Re: Paric Corporation Project No. 15051
15051-Webster University Interdisciplinary Science Building
CP-060 - ASI#36 - Added equipment to the Generator backup

Architect's Supplemental Instructions

Architect's ASI No: 036

Project:
Webster University
Interdisciplinary Science
Building

E0103.B

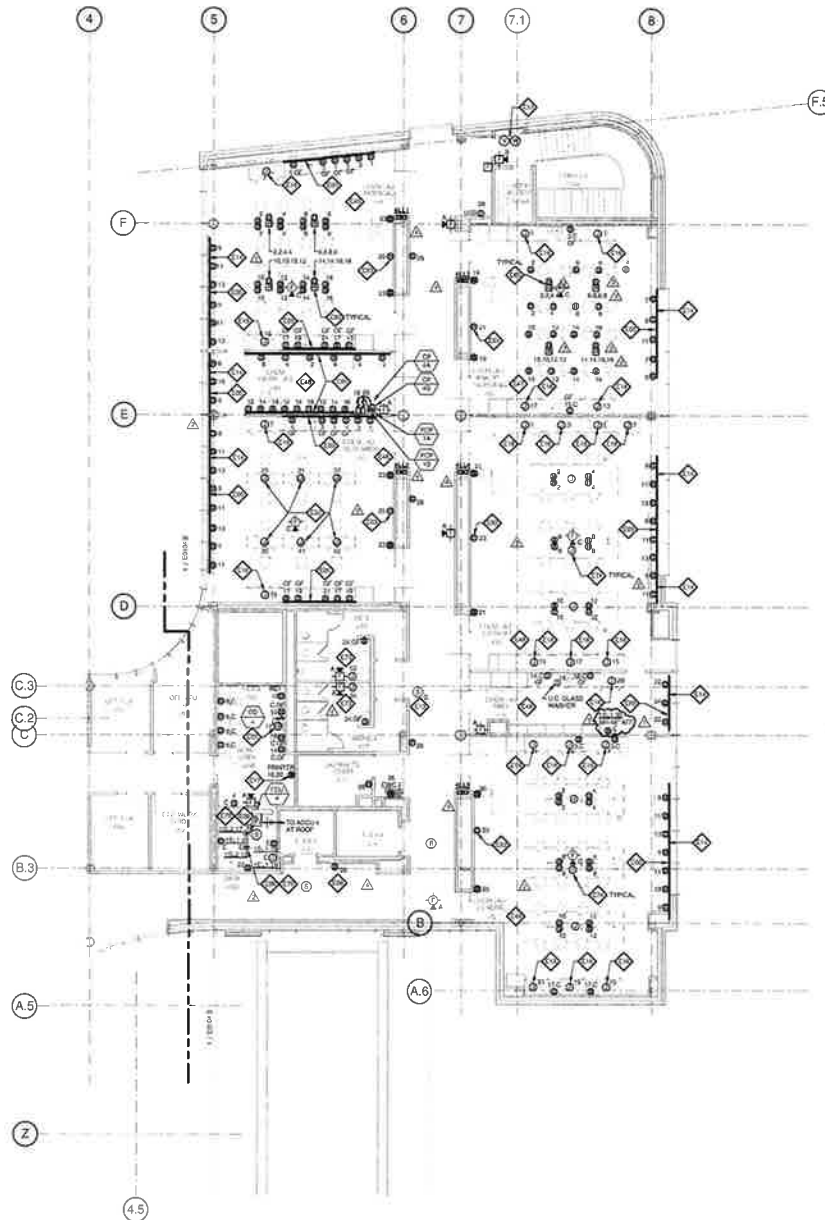
SHEET E0103.B LEVEL 03 AREA B FLOOR PLAN – ELECTRICAL

- In room 305, provide column mounted duplex receptacle.

E0503

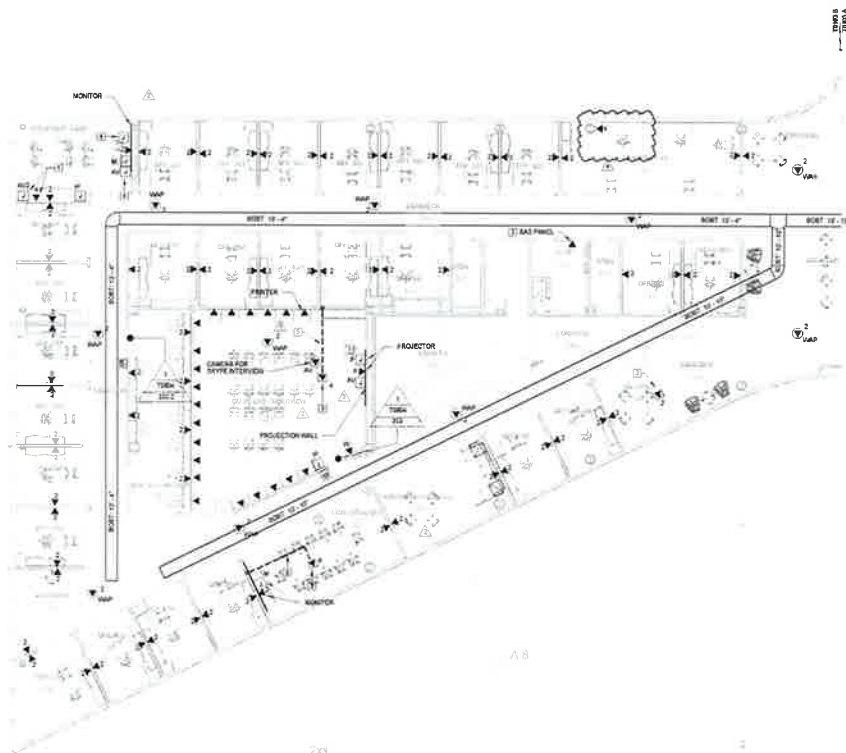
SHEET E0503 PANEL SCHEDULES

- Revise Panel 1SL1 to be 54 pole in-lieu of 42 pole.
- Update Panel 1SL1 circuit descriptions as shown.
